SUBJECT: NEW VEHICLE DEMONSTRATION / DELIVERY HOLD

Safety Recall 20S48

Certain 2020 Model Year Aviator and Explorer 1st Row Seatback Subassembly Fastener Torque

#### FIGURE 2

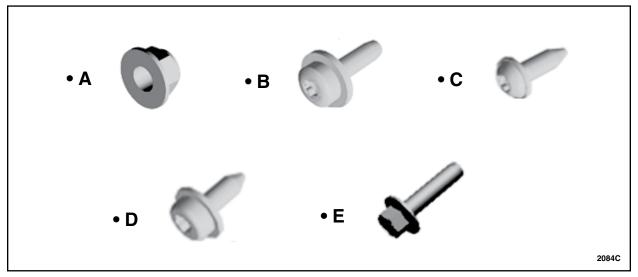
- 4. Move the front seat forward and upward to the highest position for better access when performing this procedure.
- 5. Remove the front seat backrest panel. Please follow the Workshop Manual (WSM) procedures in Section 501-01A.
- 6. Torque the fasteners.
  - For corresponding fasteners See Figure 2.
  - For Aviator See Figure 3.
  - For Explorer See Figure 4.

**NOTE:** Each seat does not have all the same fasteners in the same locations, please review the figures carefully.

**NOTE:** If any of the fasteners are missing they will need to be ordered, installed and torqued to specification.
